# CWSP SYSTEM HARDENING FIELD SCOPING DOCUMENT

PM [REDACTED]	Project Name: SH - BUCKS CREEK 1101 CB		
Notification: [REDACTED]	Region: Northern	City: Rock Creek	
Project Manager: [REDACTED]	Division: North Valley	County: Plumas

### Routes of travel for first responders and evacuees if a fire happens:

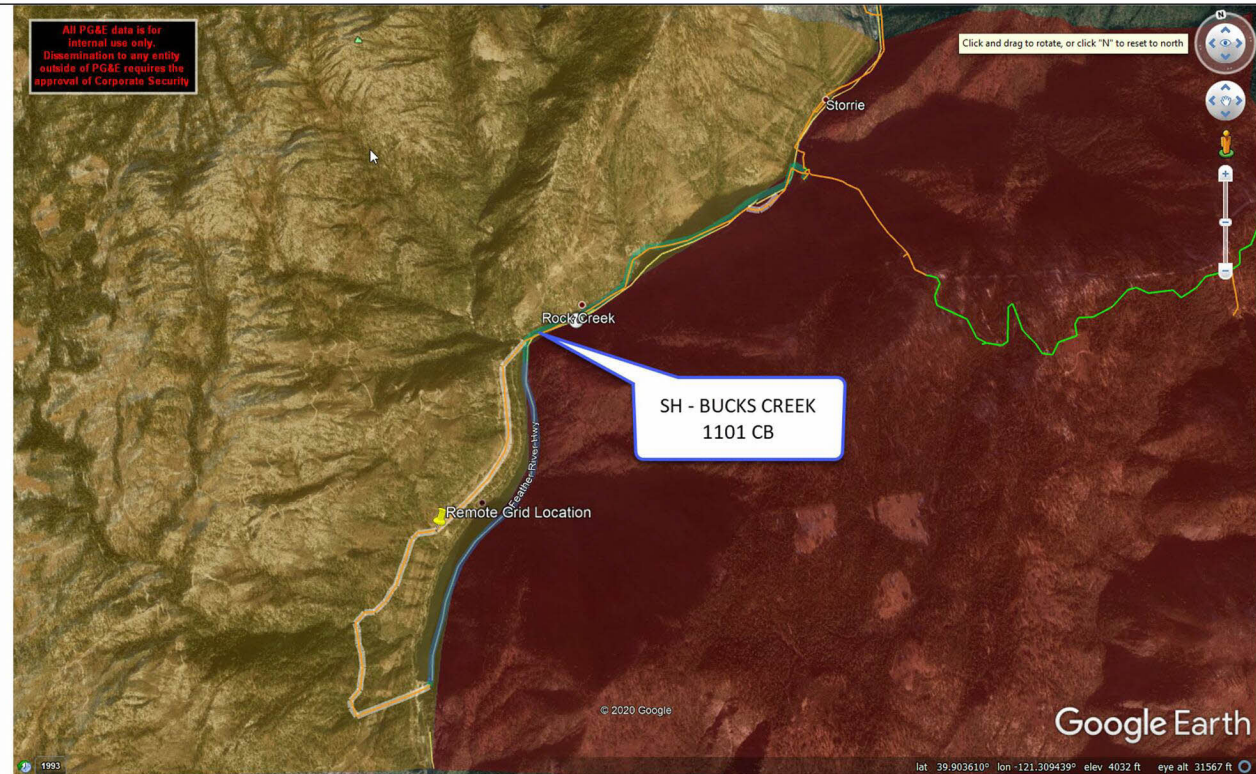
- This project crosses Highway 70 near the Bucks Creek Powerhouse and then parallels the highway for a roughly 2-mile stretch, and then runs along Storrie Rd. paralleling the Feather River on the canyon opposite side of Highway 70. Highway 70 is a main thoroughfare for ingress/egress for emergency responders and to the few residents who live in that direct area; it is also a major route for commerce both by vehicle and railroad.
- If Highway 70 was closed in this area it would make ingress and egress difficult if not impossible for responders and citizens; and, economically be a substantial hit to commerce. There are no alternative routes within the Feather River Canyon.
